Development Permit Panel

MINUTES

1. DEVELOPMENT PERMIT 20-910008
(REDMS No. 6784725)

PROPERTY LOCATION: 10431 No. 5 Road

05 REFUSE / RECYCLING SCREEN
LS-01 1:20

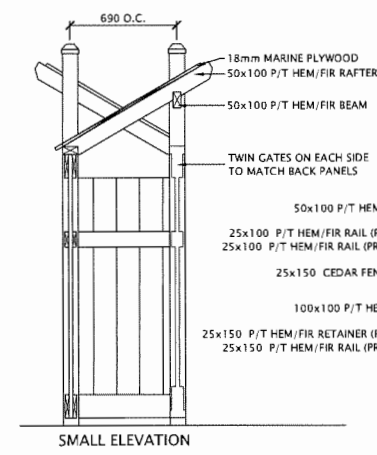
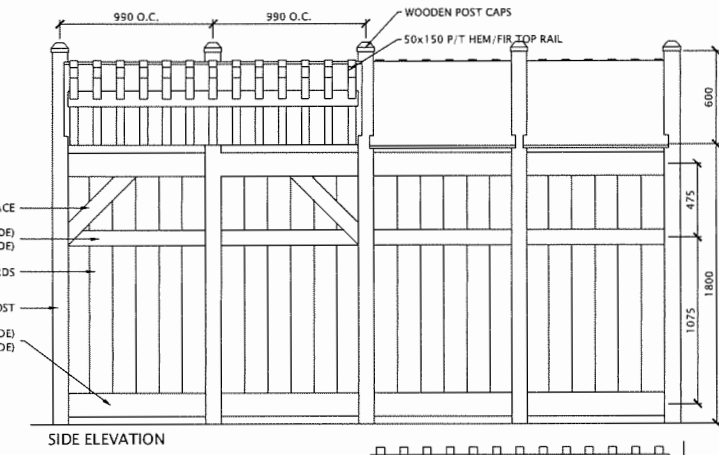
The refuse / recycling structure has been modified to give more interest and gates have been added for a neater appearance.

06 WOODEN ENTRY BRIDGE
LS-01 1:20

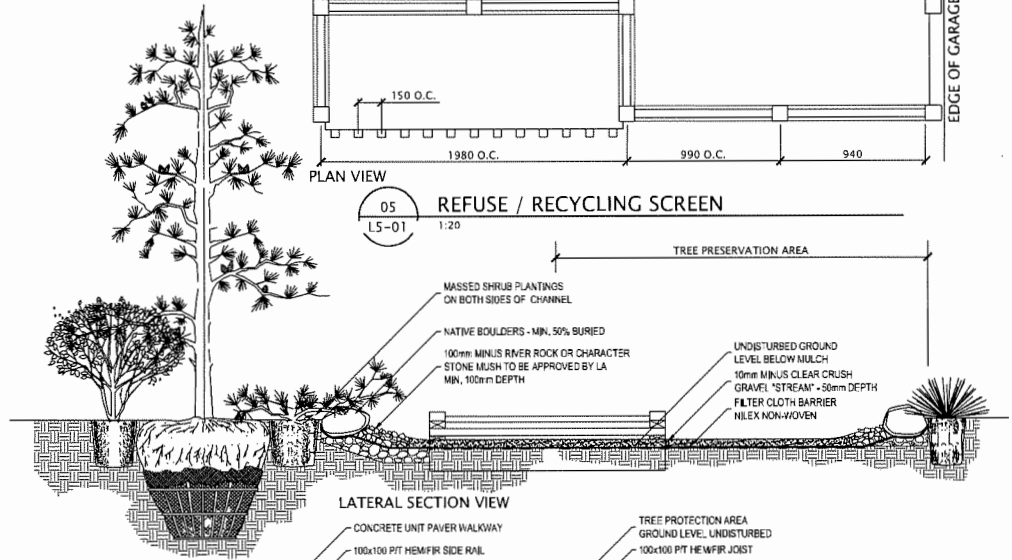
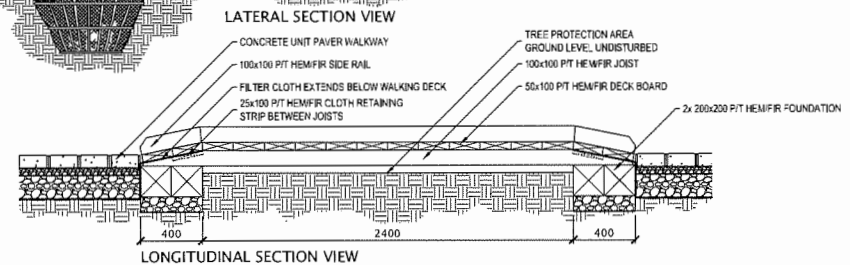
- One on-site palm tree (tag #3) is proposed to be retained in the front yard of proposed Lot 2. Tree retention was secured through the rezoning, and a Tree Management Plan is included in the Development Permit on Plan 11. A bridge pathway will be included as part of maintaining the central pathway connection but also avoiding any impact on the critical root zone, and site grade will be maintained. Installation of tree protection fencing is required prior to demolition of the existing dwelling, and arborist supervision is required for all works within the tree protection area.
